SUBJECT: AMENDMENT NOS. 89 AND 82 TO FACILITY OPERATING LICENSE NOS. DPR-42 AND DPR-60: (TAC NOS. 71536 AND 71537)

PRAIRIE ISLAND NUCLEAR GENERATING PLANT, UNIT NO. 1

PRAIRIE ISLAND NUCLEAR GENERATING PLANT, UNIT NO. 2

SAFETY EVALUATION BY THE OFFICE OF NUCLEAR REACTOR REGULATION

FIGURE TS 3.1-1

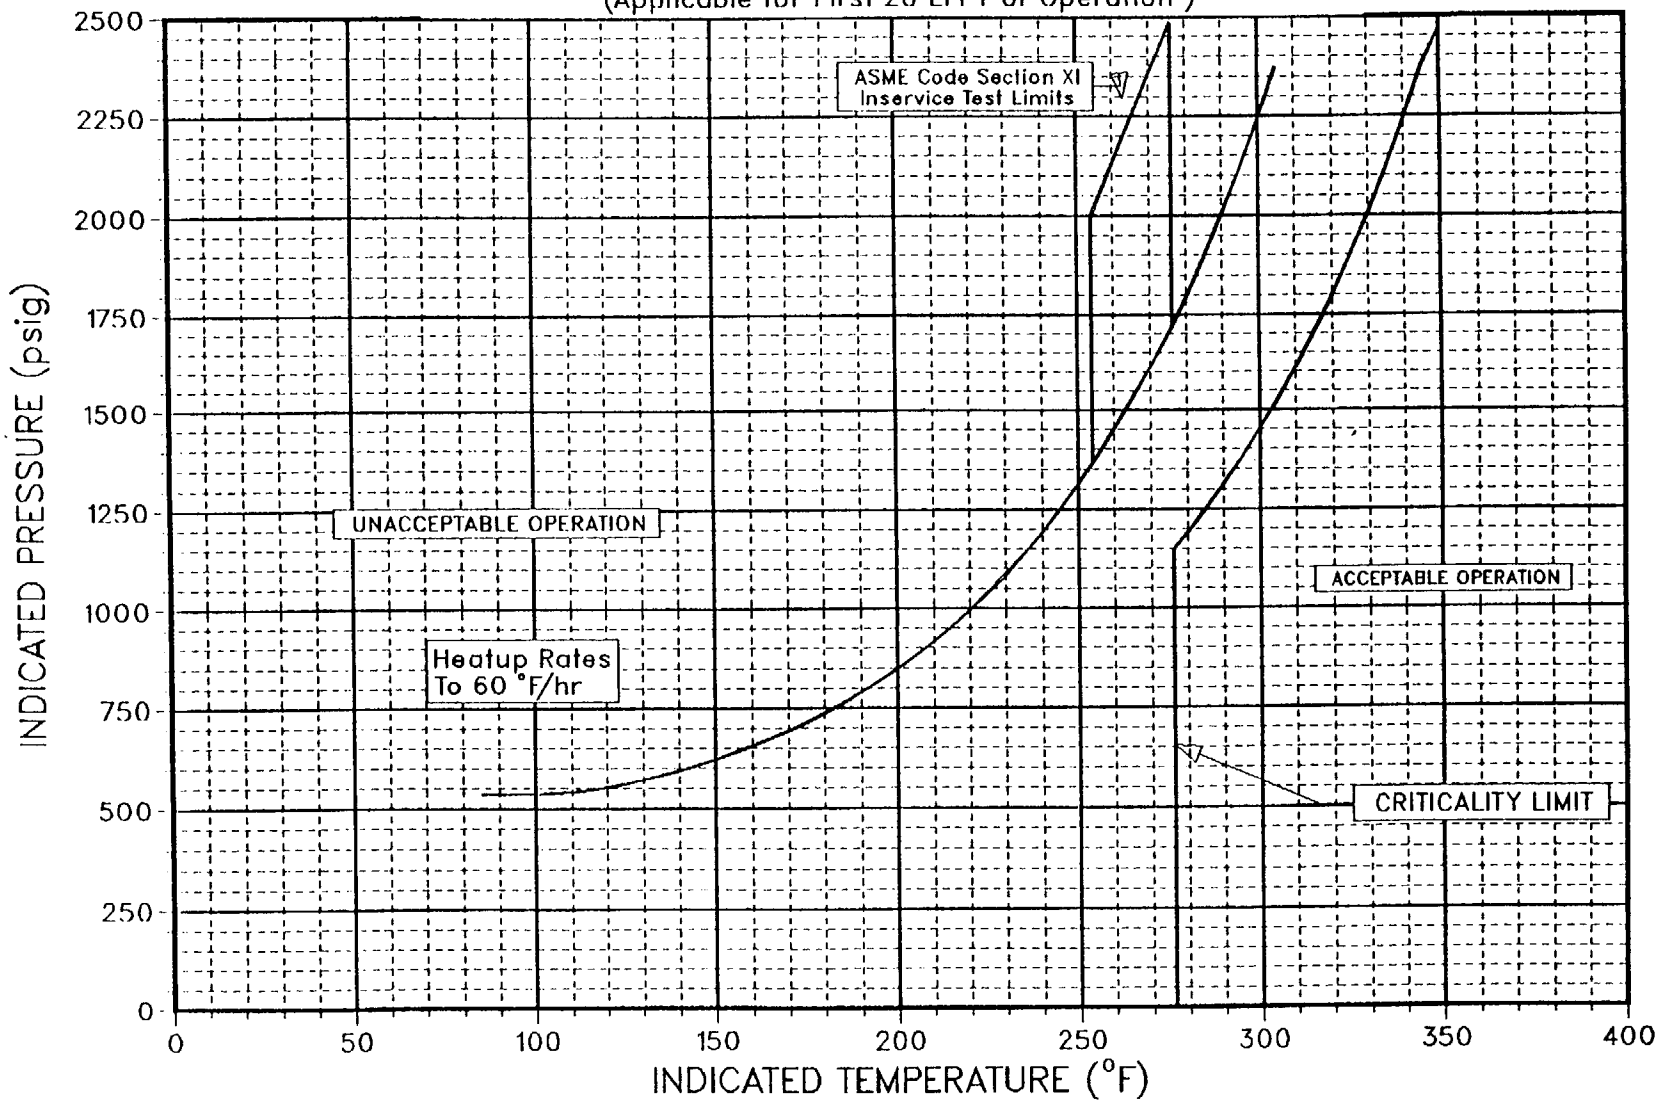
1. The effective limitation of existing reactor coolant system heatup and cooldown curves are revised from 15 to 20 effective full power years.

UNIT 1 and UNIT 2
REACTOR COOLANT SYSTEM HEAT UP LIMITATIONS
(Applicable for First 20 EFPY of Operation)

We have evaluated the effect of neutron irradiation embrittlement on each beltline material in PINGP-1 and PINGP-2 reactor vessels. The amount of neutron irradiation embrittlement was calculated in accordance with RG 1.99, Rev. 2. We have determined that the material with the highest ART (most embrittled) at 20 EFPY for both units was the circumferential weld between the intermediate and lower shells in Unit 2.

Based on the above evaluation, the staff concludes that the proposed P/T limits on the reactor coolant system for heatup, cooldown, leak test, and criticality are valid through 20 EFPY, because the limits conform to requirements of Appendices G and H to 10 CFR Part 50. The licensee's submittal also satisfies Generic Letter 88-11, because the licensee used the method in RG 1.99, Rev. 2, to calculate the ART. Hence, the proposed P/T limits that would be incorporated into the PINGP-1 and PINGP-2 Technical Specifications are acceptable.

FIGURE TS 3.1-2

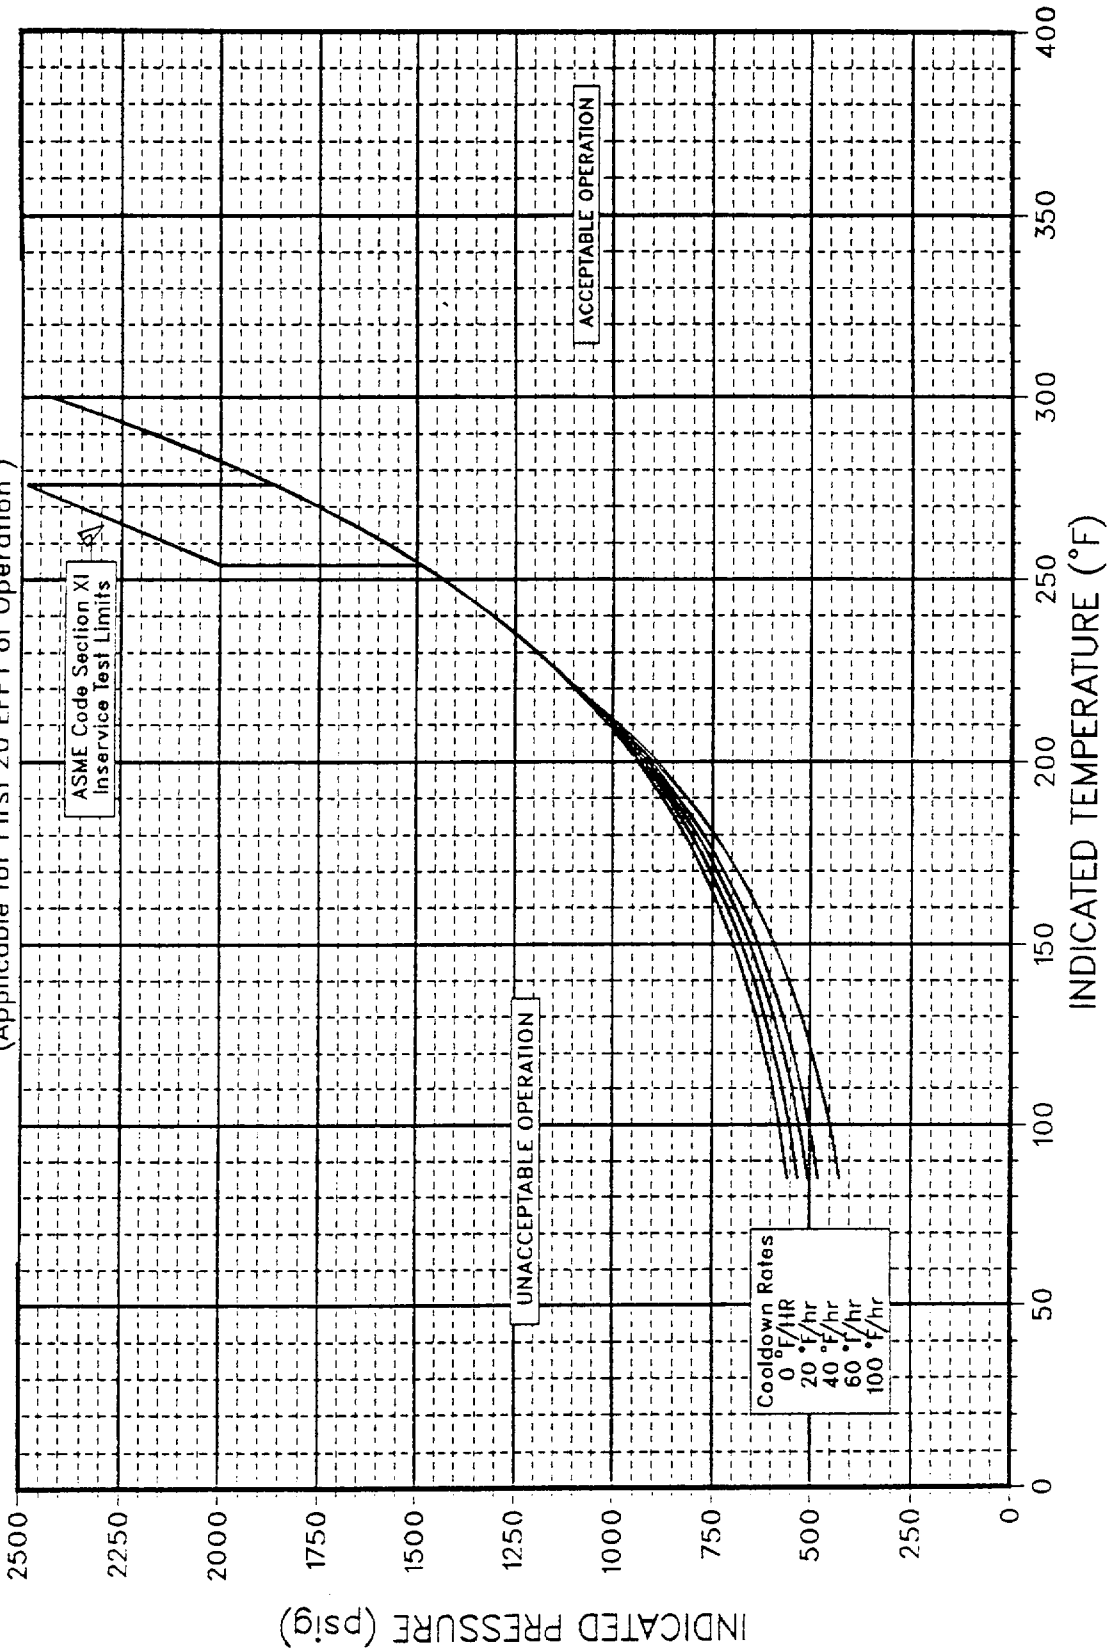
UNIT 1 and UNIT 2
REACTOR COOLANT SYSTEM COOLDOWN LIMITATIONS
(Applicable for First 20 EFPY of Operation)
